SUNDRY NOTICES AND REPORTS ON WELLS

1. Type of Well <input type="checkbox"/> Oil Well <input checked="" type="checkbox"/> Gas Well <input type="checkbox"/> Other	8. Well Name and No. MARQUARDT 12 PENN FEDERAL 1
2. Name of Operator CIMAREX ENERGY COMPANY OF CO	9. API Well No. 30-015-33461-00-C2
3a. Address 600 N MARIENFELD STE 600 MIDLAND, TX 79701	10. Field and Pool or Exploratory Area SAGE DRAW-WOLFCAMP, EAST WHITE CITY-PENN (GAS)
3b. Phone No. (include area code) Ph: 432-687-3033	11. County or Parish, State EDDY COUNTY, NM
4. Location of Well (Footage, Sec., T., R., M., or Survey Description) Sec 12 T25S R26E SWNE 880FSL 1760FEL

Permanent Abandonment of Federal Wells
Conditions of Approval

Marquardt 12 Penn Federal #1

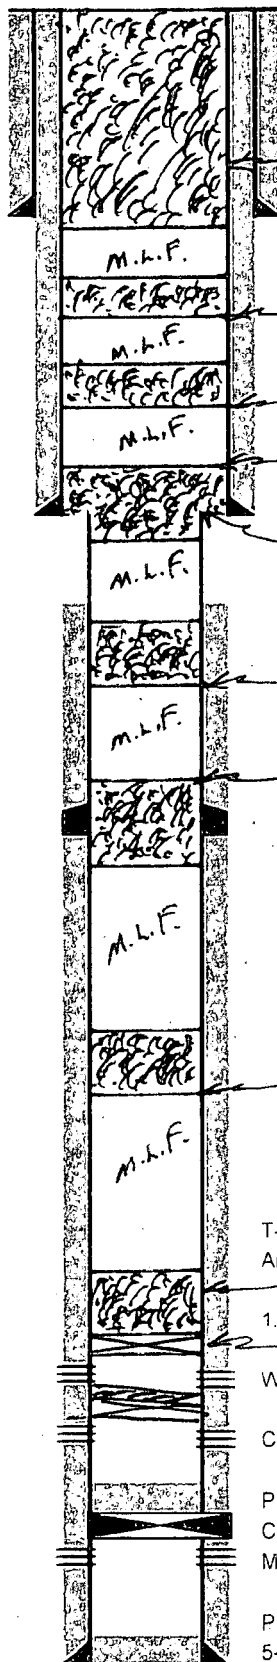
WOC Tag. Verify.

Add Plug Casing/Cyl. Set CIBP @ 10065. Dump 35 cm.

Dump 35' cmt.
